MONA OFFSHORE WIND PROJECT

Scoping Opinion

Document Reference: J8
APFP Regulations: 5(2)(a)
October 2023
Rev02

Adopted by the Planning Inspectorate (on behalf of the Secretary of State) pursuant to Regulation 10 of The Infrastructure Planning (Environmental Impact Assessment) Regulations 2017

Figure 11.2.3 Position and geographical area of herring closures within the Irish Sea as defined by Council Regulation (EC) No 850/98, amended by EC 2723/1999.

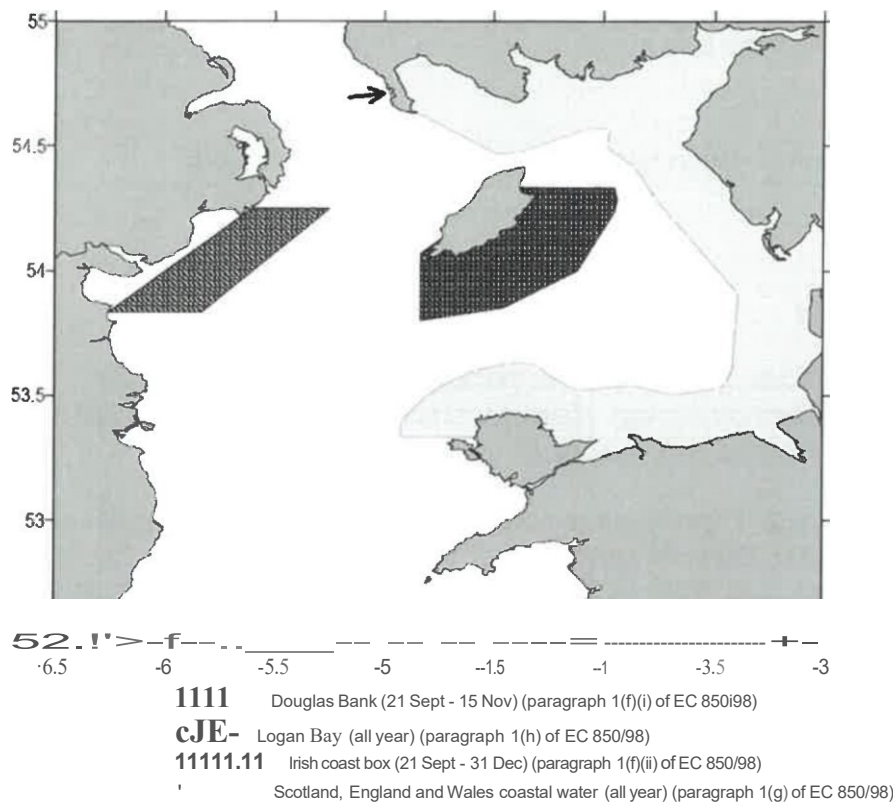
- Also please note the statutory herring spawning closure in Manx waters in relation to sections **4.2.4.19 - 21**. This was originally included within EU Council Regulations (EC) No 850/98 (amended by EC 2723/1999, and has since been rescinded. However, the closure remains in place within Manx law : <https://www.gov.im/media/1364592/sea-fisheriestechnicalmeasuresbye-laws20007.pdf> (byelaw 18).
